DeltaPSU Product Notice

Product Notice: EUCO-2K1200GxA Luminaire Over Temperature Protection Function Upgrade

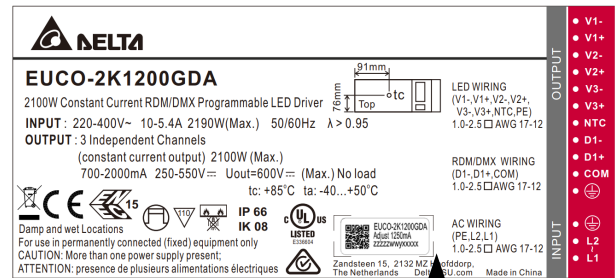
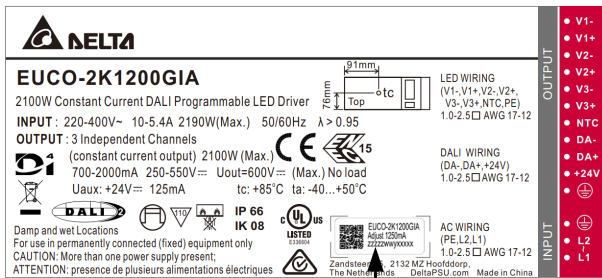
To better serve our customers, Delta has upgraded the luminaire over temperature protection (OTP) function for the [EUCO-2K1200GIA](#) and [EUCO-2K1200GDA](#) LED drivers. This enhancement introduces compatibility with a 10Kohm NTC, offering an alternative to the default 33Kohm NTC. This upgrade does not affect any other features or functions of the driver.

Before		After	
Compatible NTC Type	Date Code Range	Compatible NTC Type	Date Code Range
33Kohm NTC	Before "ZZZZZ124XXXXX" (Before the 12 th week of 2024)	33Kohm NTC 10Kohm NTC	Starting from "ZZZZZ124XXXXX" (Start from the 12 th week of 2024)
